CM CLARIFICATION #004

PROJECT: CNE Tahlequah Casino

ADDENDUM # 001

Tahlequah Casino Addendum #01 summary

SHEET NUMBER:
S3.3

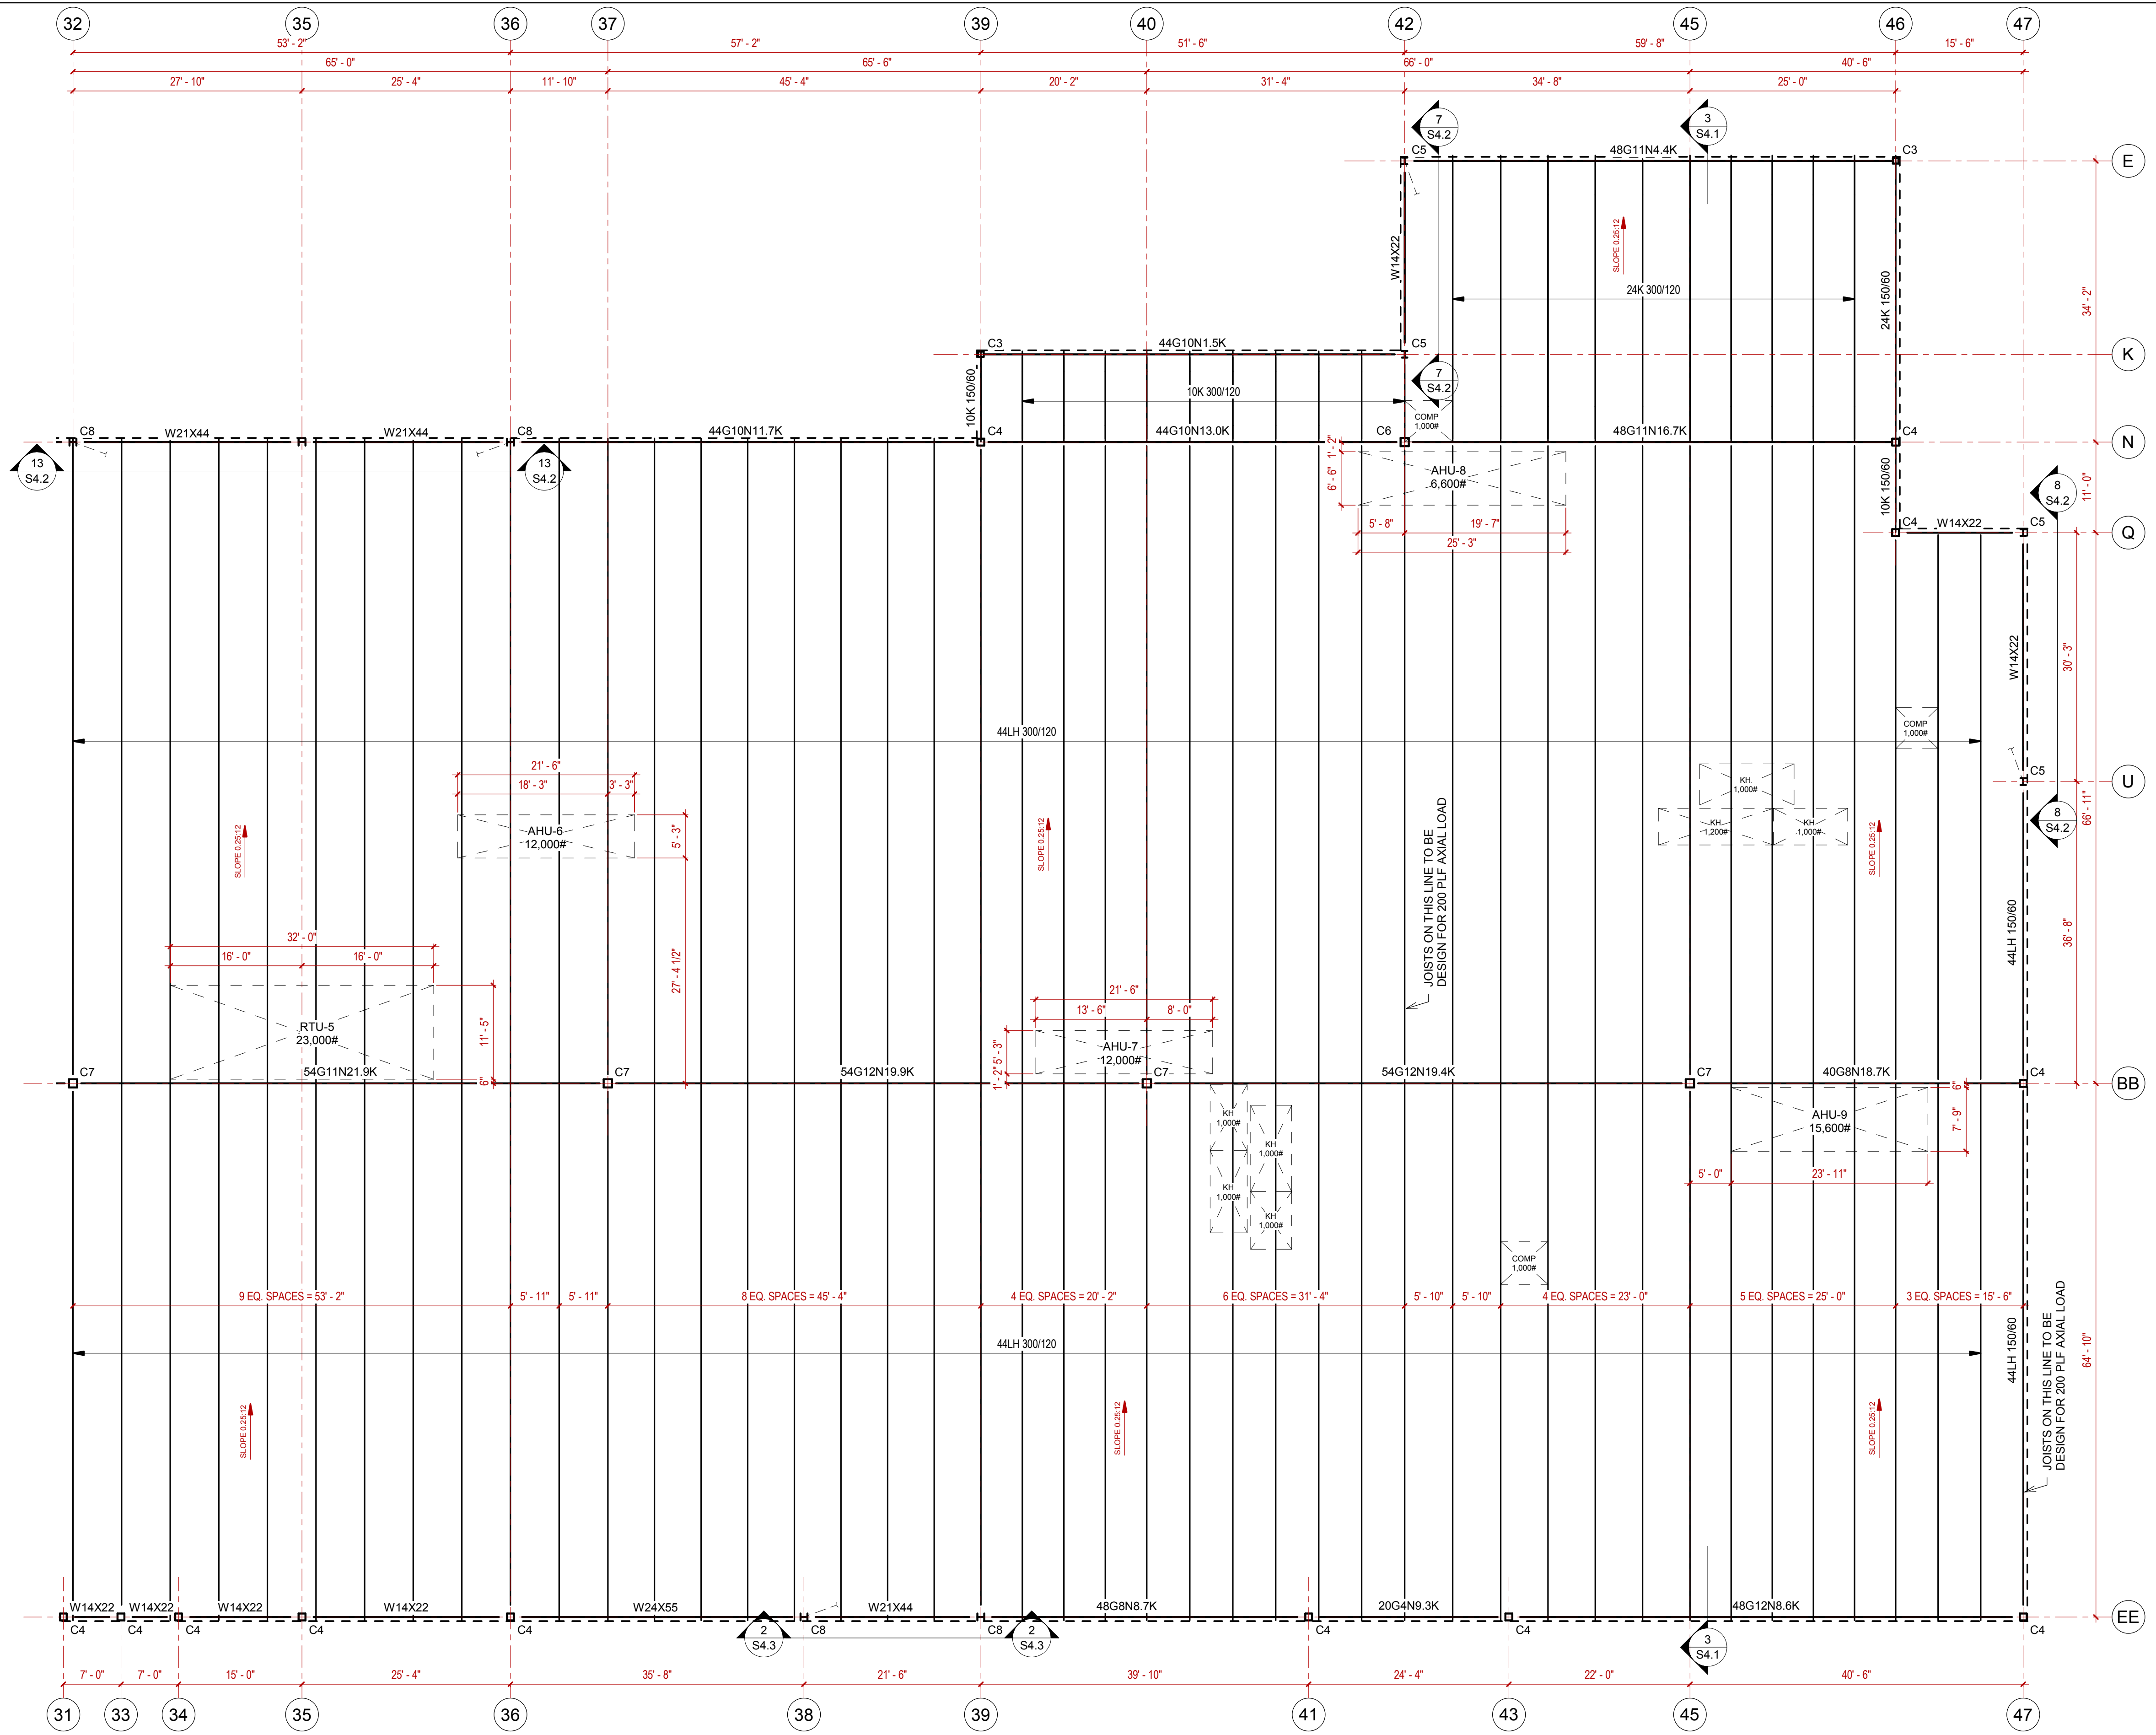
<ul style="list-style-type: none"> • Removed joist girders on gridline 'U' • Revised joist framing. Revised joist girder loadings
S3.3	<ul style="list-style-type: none"> • Removed brace elevation 42/44-E • Removed column @ E-44 • Revised joist framing. Revised Joist girder loadings
S3.4	Revised detail 7/S3.4
S4.1	Revised section 2/S4.1
S4.2	<ul style="list-style-type: none"> • Revised column size in framing elevation. • Revised brace sizes in framing elevations • Added detail callouts to framing elevations. • Frame elevation moved from grid '19' to '21' • Removed frame elevation @ grid 'E'
S4.3	<ul style="list-style-type: none"> • Revised column size in framing elevation. • Added detail callouts to framing elevations • Added braced frame details
S5.1	Added sheet S5.1

SHEET NUMBER:
PU1.1

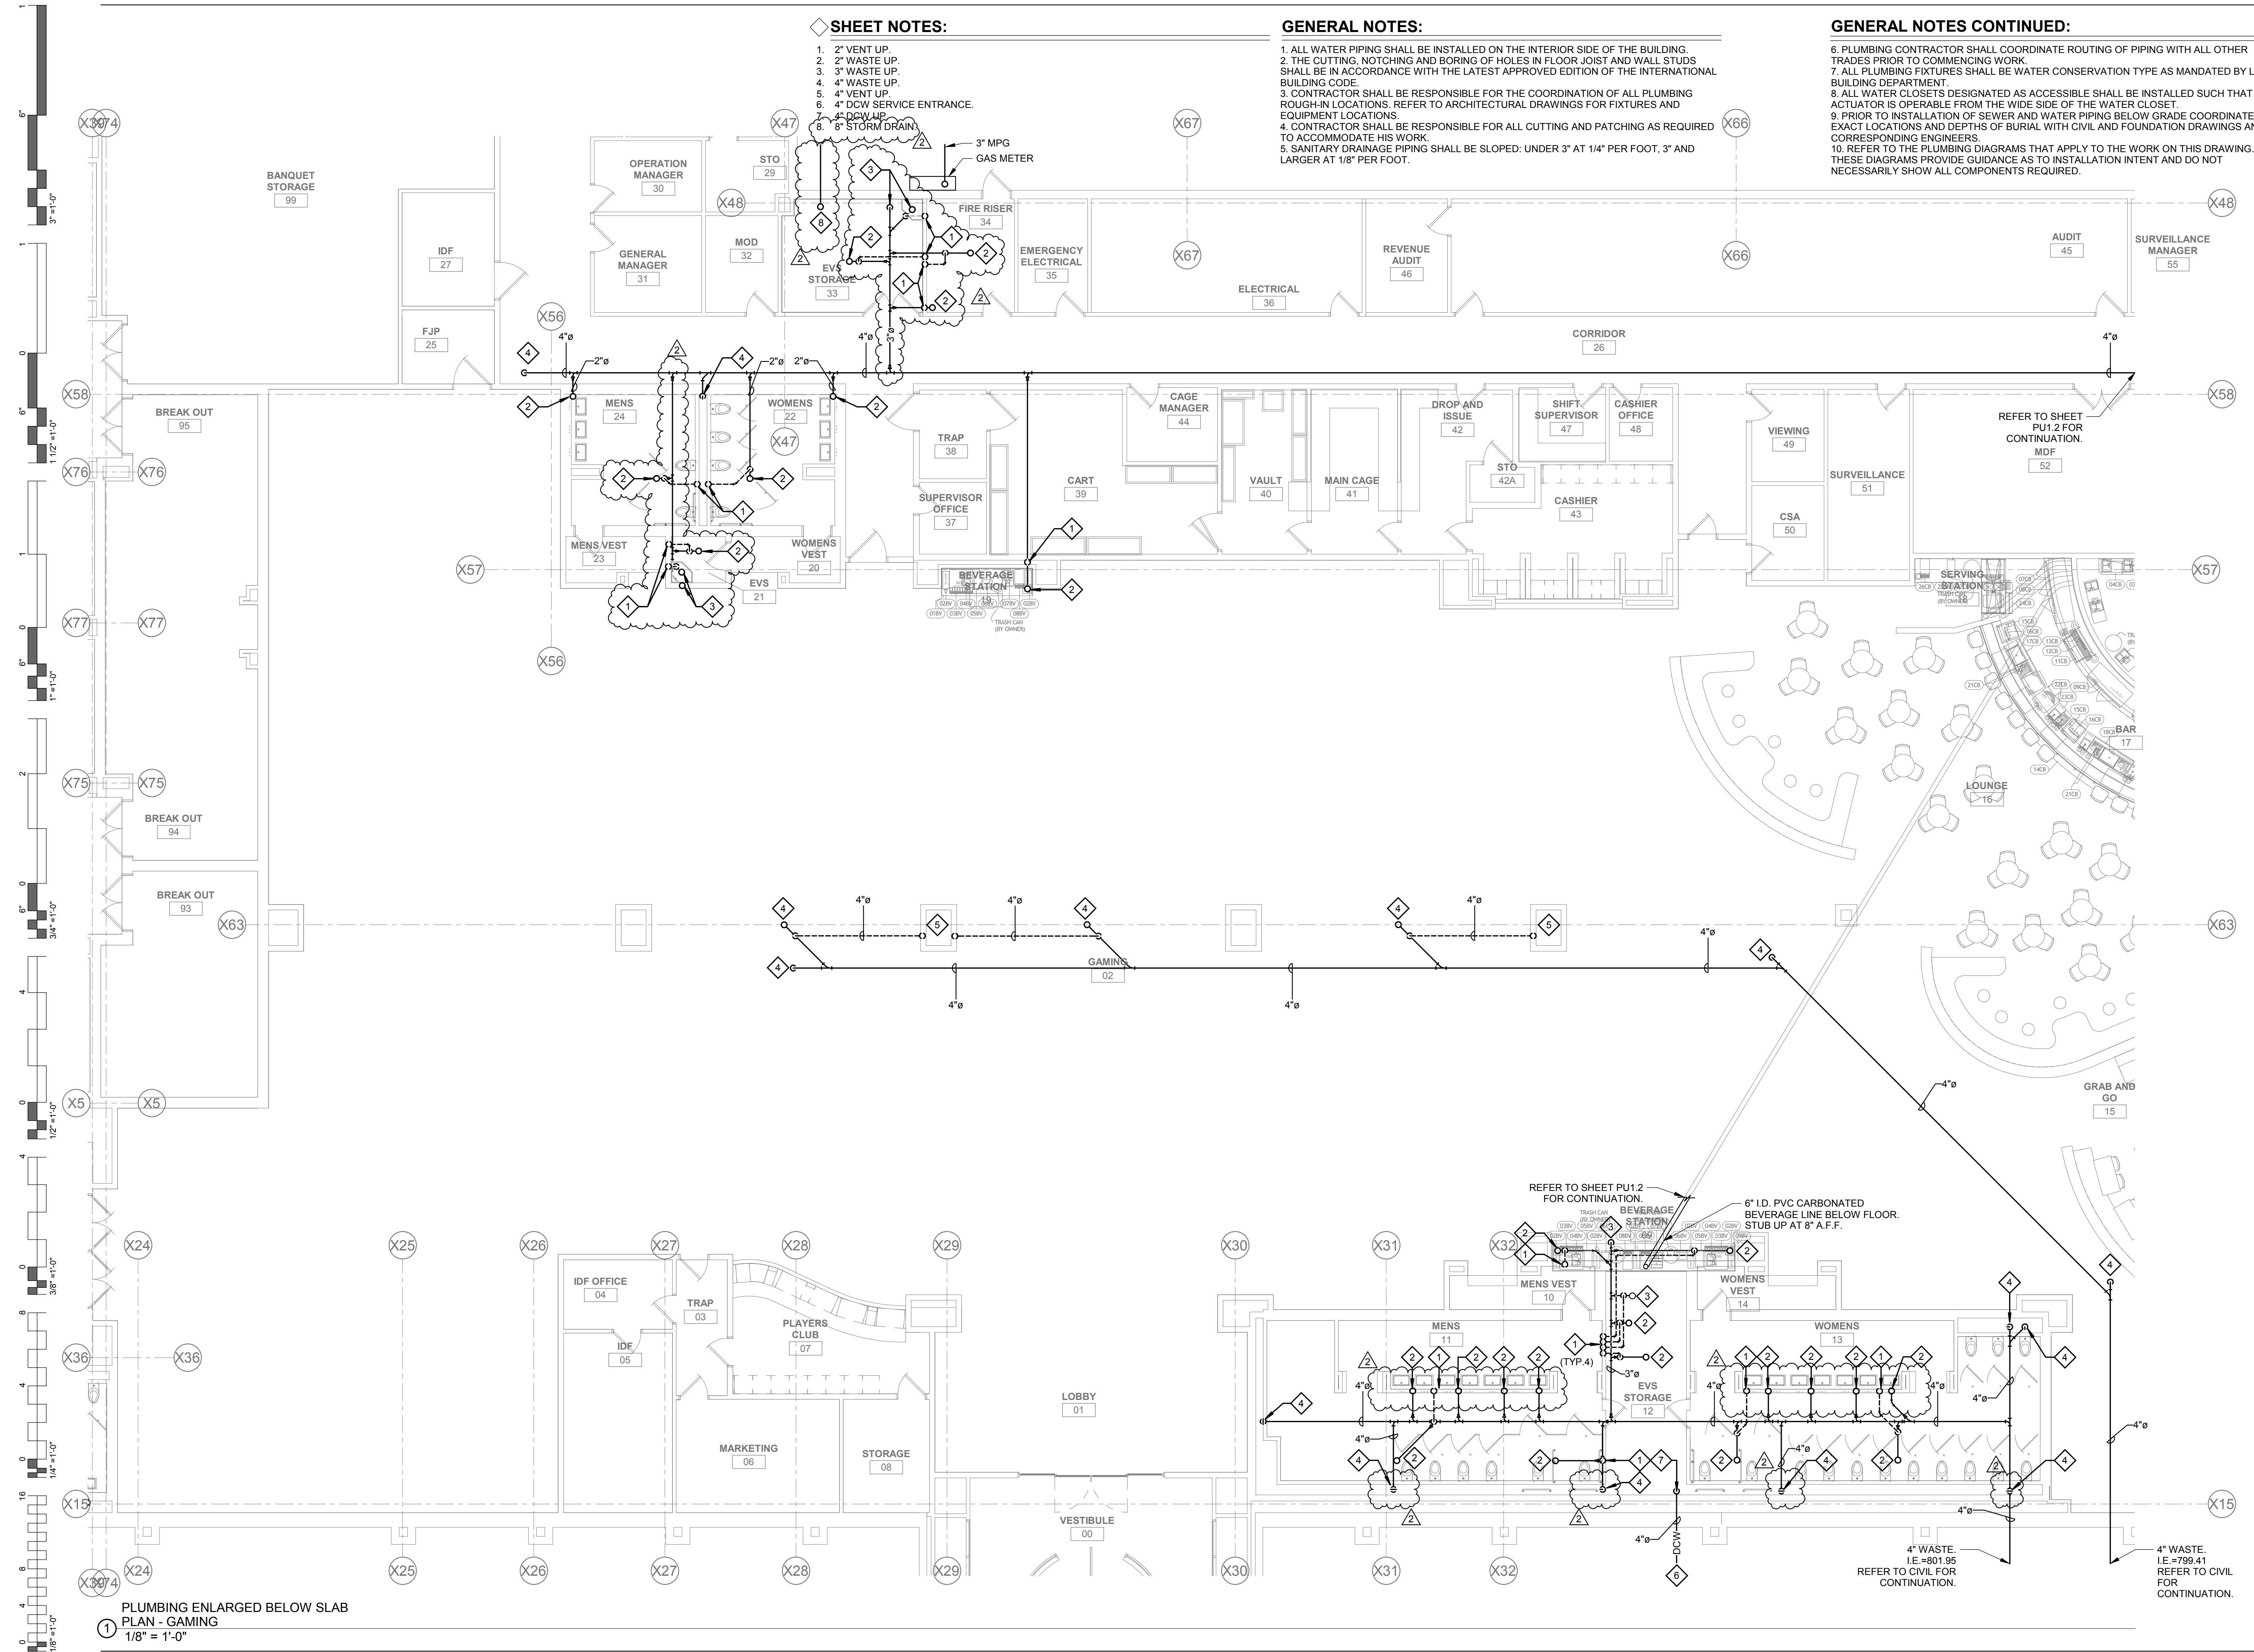
<u>Sheets</u>	<u>Description</u>
PU1.1	Added (1) 8" Storm drain penetration / floor drain / mop sink to EVS Storage 33. Added floor drain / mop sink EVS 21. Moved waste and vent lines into architectural wall shift in Mens 11 & Womens 13. Added floor drain / sink to Fire Riser 34.
PU1.2	Added carbonated beverage/liquor lines in Bar 17. Extend waste/vent lines to hand sinks in Kitchen 75 & 79. Added mop sink & floor drain to EVS 79B and mop sink to 79A. Relocated vent lines to consolidated column in Bar 85. Added carbonated beverage lines to Bar 85.
PU1.3	Added (2) 8" storm drain penetrations.
PU1.4	Extend waste/vent lines to hand sinks in Banquet Food Preparation 98. Added (3) 8" storm drain penetrations.
PU1.5	Added (2) 4" storm drain penetrations. Added mop sink and floor drain to EVS 91 & 93.
